**Subject: Draft Housing Element and related 4-4-22 zoning text amendments (Item 7-C on 4-19-22 City Council agenda)**

**Subject: Housing Element updates**

MF (MULTI FAMILY) ZONE 2  
DEVELOPMENT OPPORTUNITY ZONE  
LINCOLN AVE TO APPEZZATO

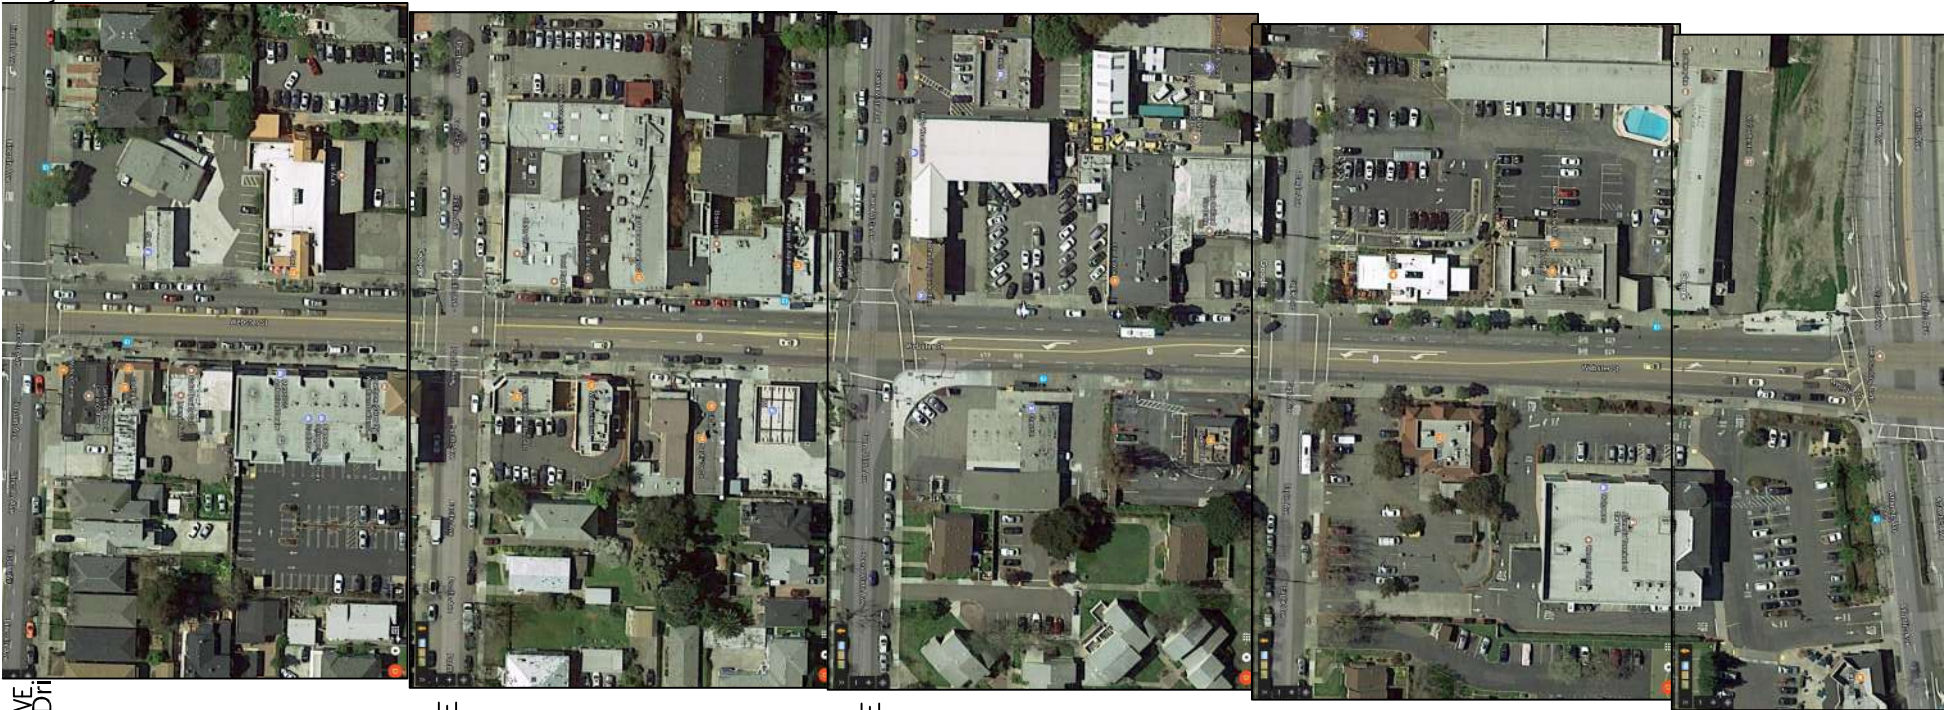
45' HT ALLOWED @ STREET FRONT  
WITH 3 FLOORS  
55' HT ALLOWED @ SIGHT LINE  
SETBACK WITH 4TH FLOOR

• 55' HT ALLOWED @ STREET  
FRONT WITH 4 FLOORS

• 55' HT ALLOWED @ STREET FRONT  
WITH 4 FLOORS  
• 65-70' HT ALLOWED @ SIGHT LINE  
SETBACK WITH 5 FLOORS

• 55' HT ALLOWED @ STREET FRONT  
WITH 4 FLOORS  
• 65-70' HT ALLOWED @ SIGHT LINE  
SETBACK WITH 5 FLOORS  
• ±77' HT ALLOWED @ SIGHT LINE  
SETBACK WITH 6TH FLOOR

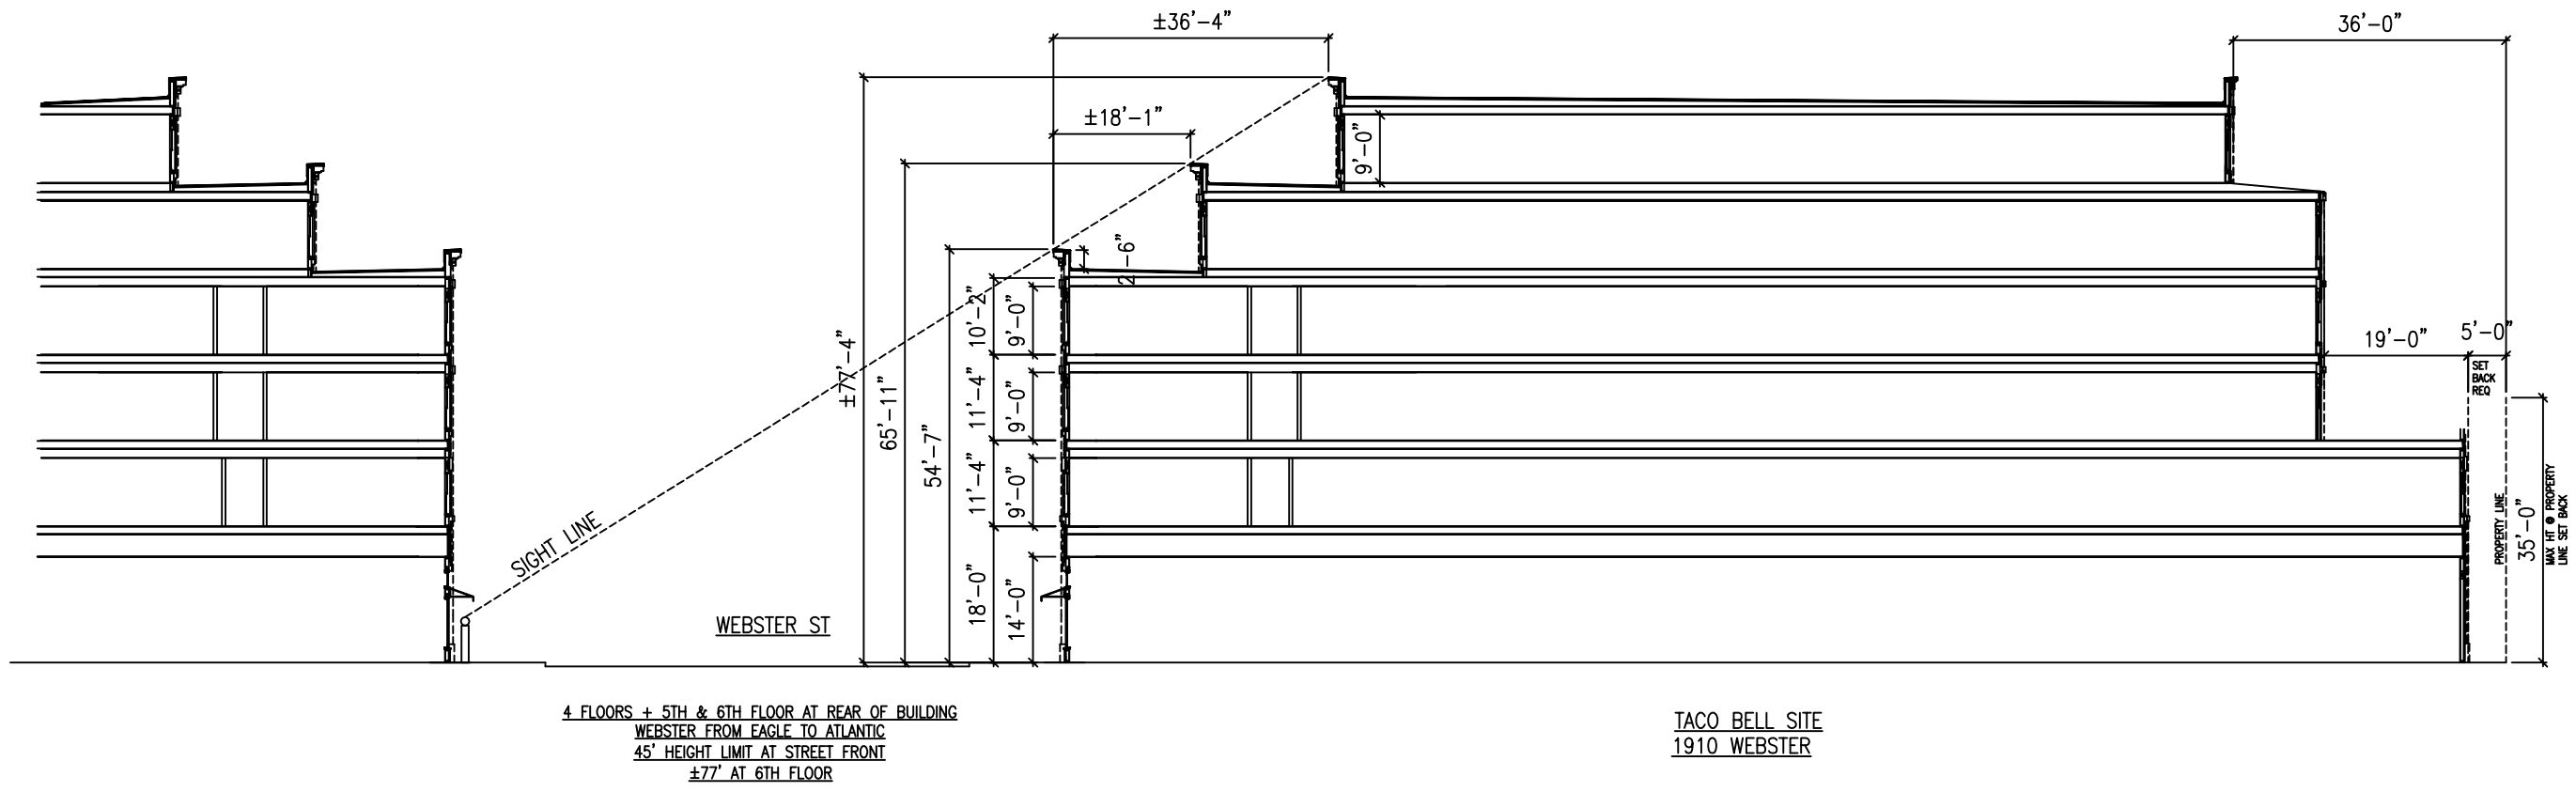
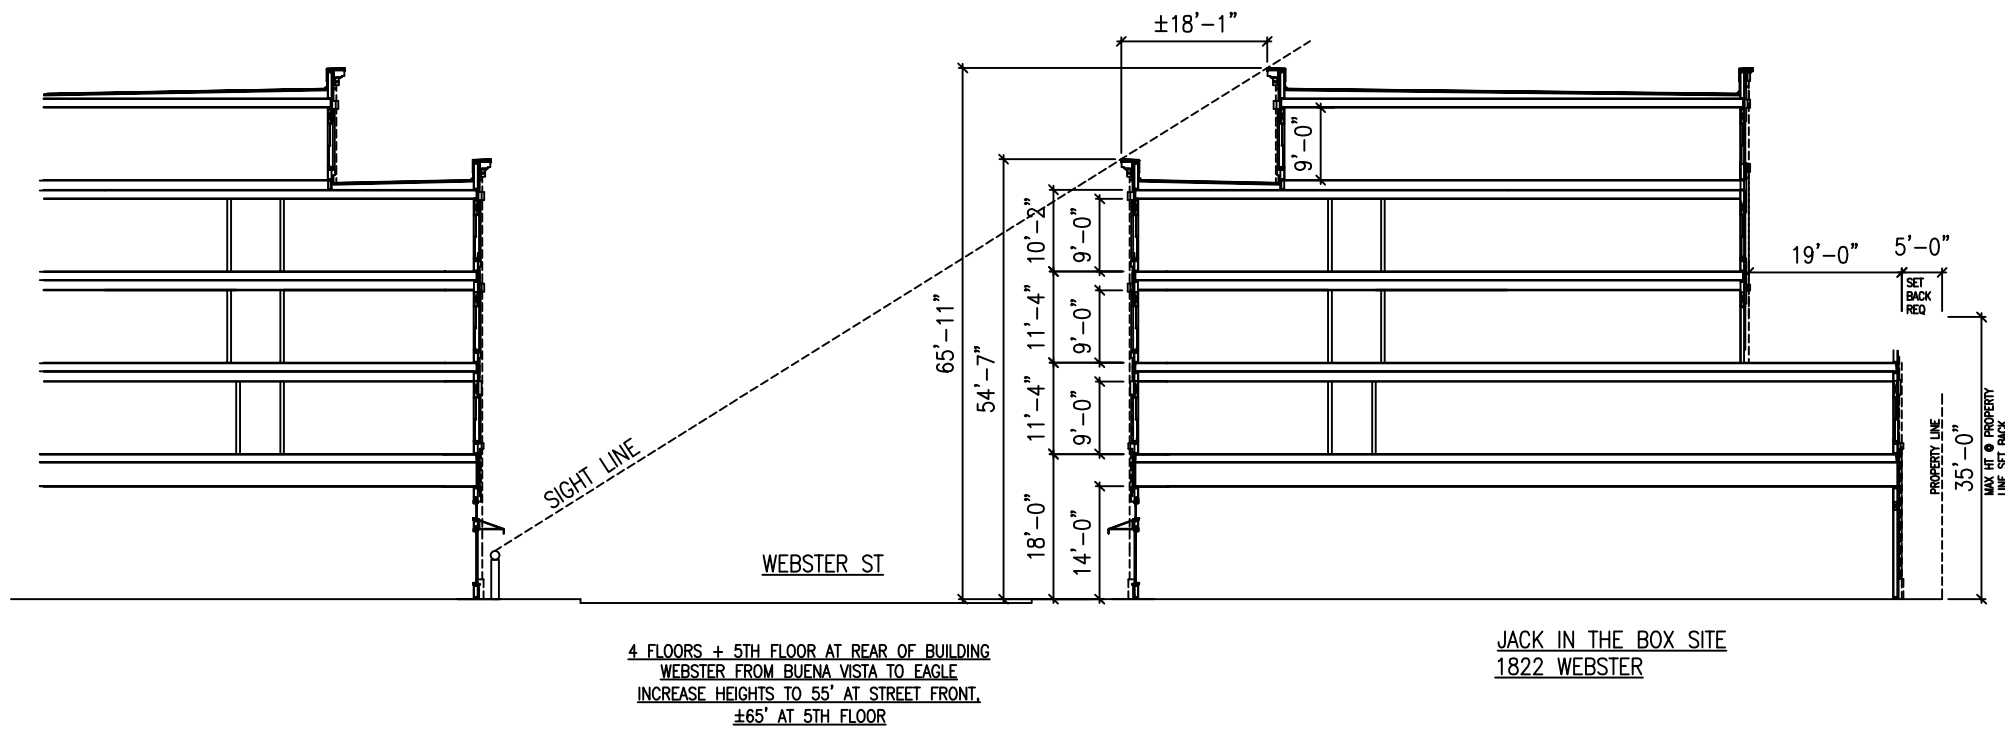
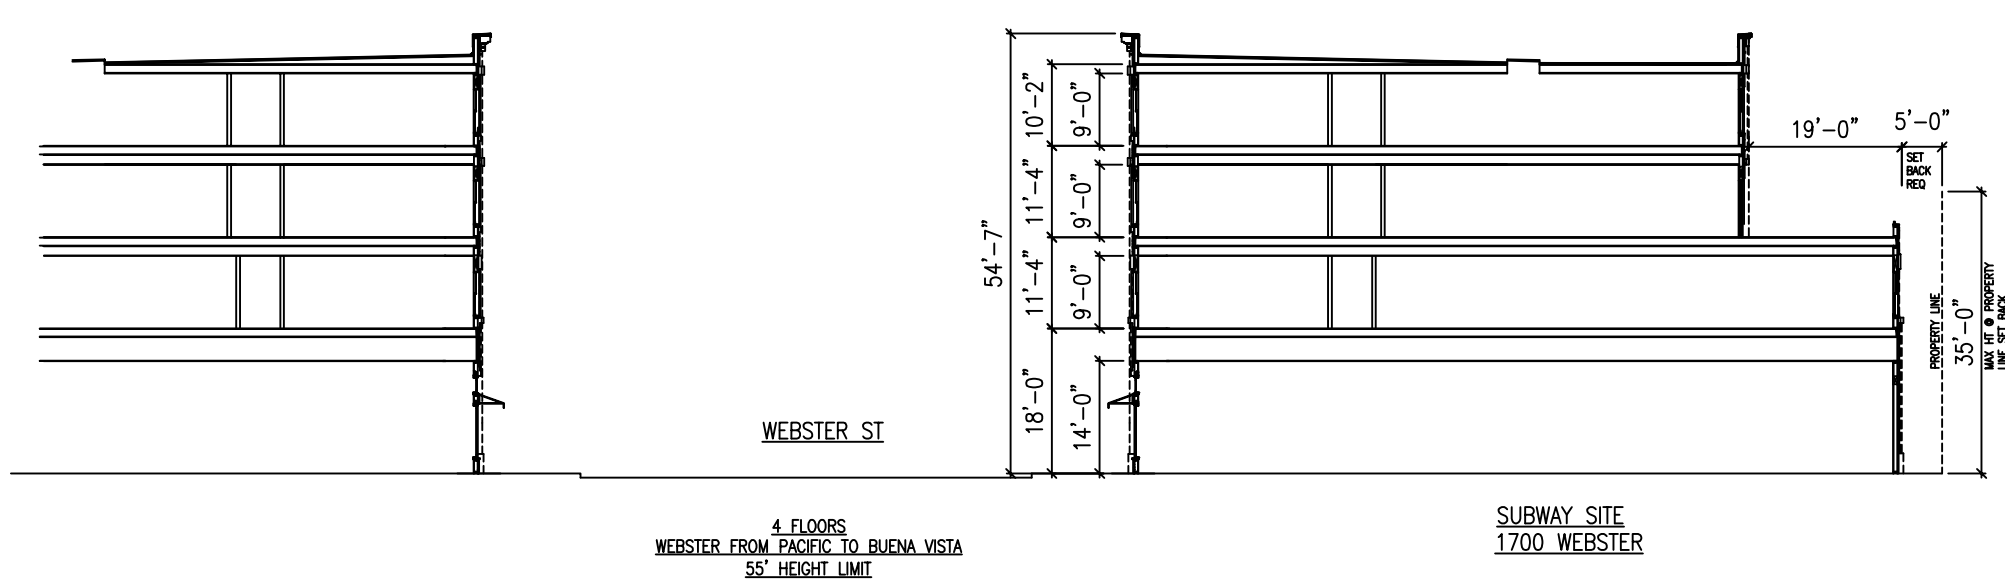
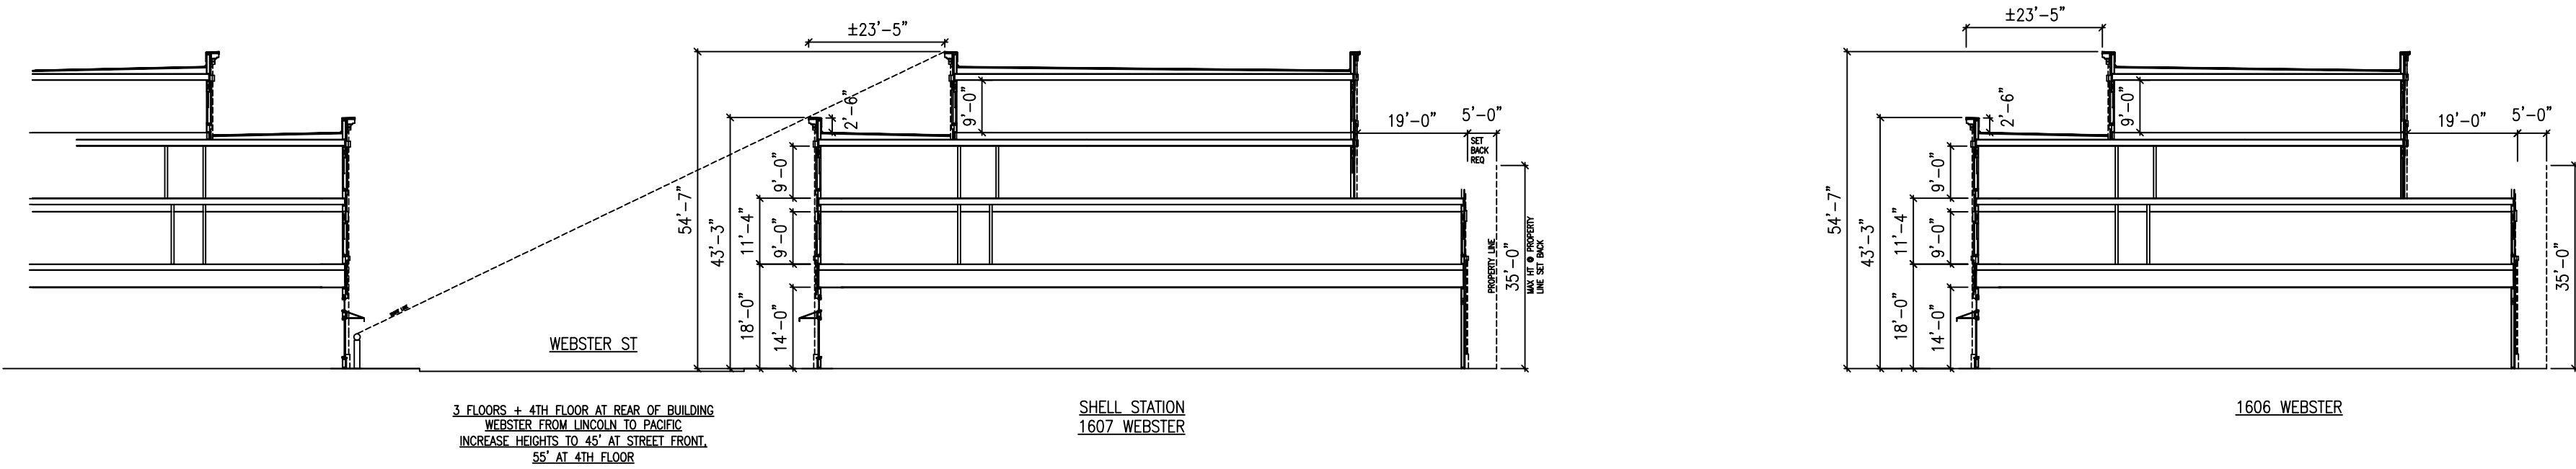
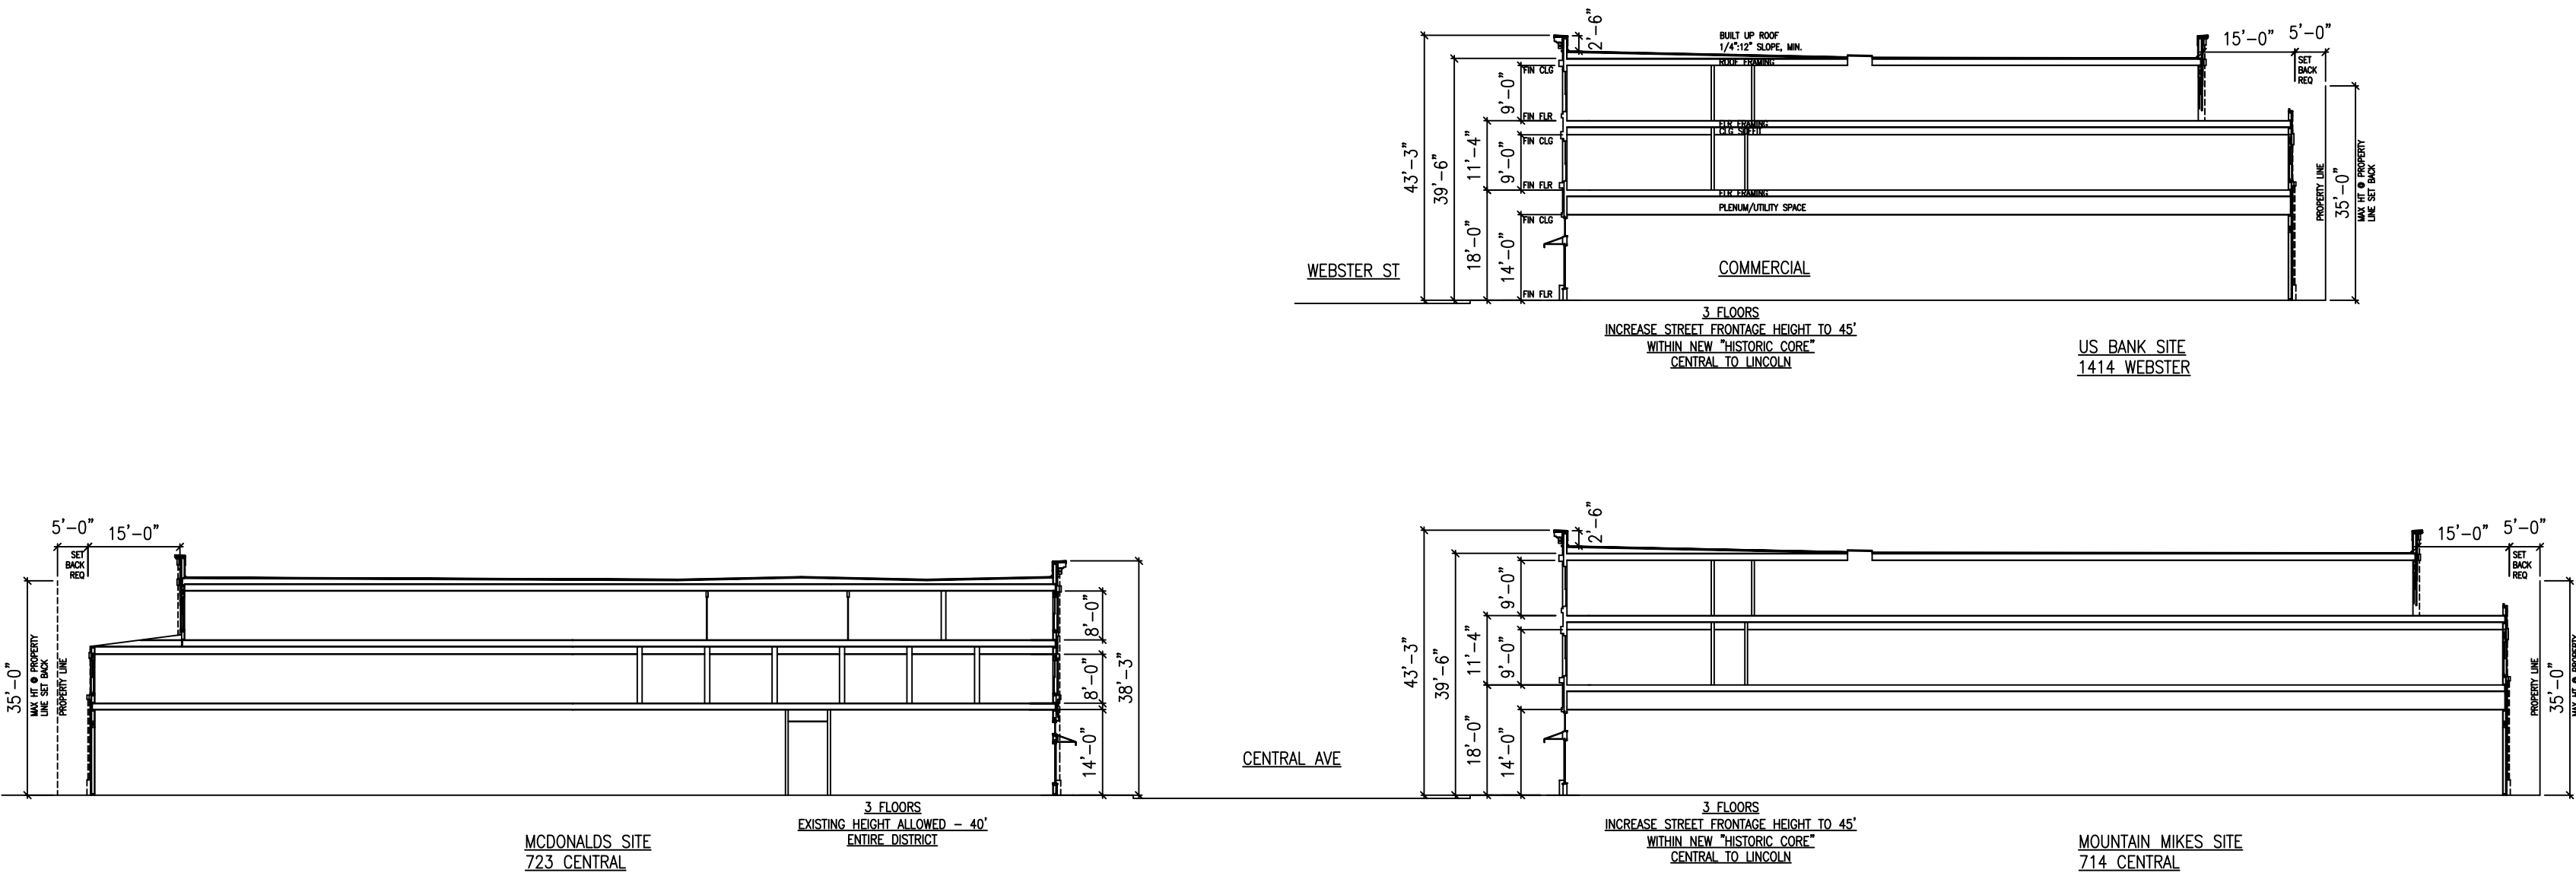
- Properties fronting onto the south side of Central Avenue - fifty five (55') feet, provided that any portion of the building that exceeds forty five (45') feet is set back at least ten (10') feet from the face of the building.
- Properties fronting onto Webster Street between Central Avenue and Lincoln Avenue, and properties fronting onto the north side of Central and south side of Lincoln - forty five (45') feet;
- Properties fronting onto Webster Street between Lincoln Avenue and Pacific Avenue and properties fronting onto the north side of Lincoln and the south side of Pacific - fifty five (55') feet, provided that any portion of the building that exceeds forty five (45') feet is set back at least ~~ten (10')~~ feet from the face of the building. *(e both front + rear PL)*

- Properties fronting onto Webster Street between Pacific Avenue and Buena Vista Avenue and properties fronting onto the north side of Pacific and the south side of Buena Vista Avenue - fifty five (55') feet; (SAME 24' SET BACK? & REAR?)

- Properties fronting onto Webster Street between Buena Vista Avenue and Eagle Avenue and properties fronting onto the north side of Buena Vista or the south side of Eagle- sixty five (65') feet, provided any portion of the building that exceeds fifty five (55') feet is set back at least ~~ten (10')~~ <sup>18'</sup> feet; and, (+ 24' SET BACK & REAR FT?)

- Properties fronting onto Webster Street between Eagle Ave and Atlantic Avenue and properties fronting onto the north side of Eagle or south side of Atlantic- eighty five ~~(85')~~ <sup>80</sup> feet. w/ 18' SET BACK @ 5th FLR + 36' SET BACK @ 6th FLR + 24' @ REAR

2022-01-31  
match rear setbacks to  
duplicate front setbacks
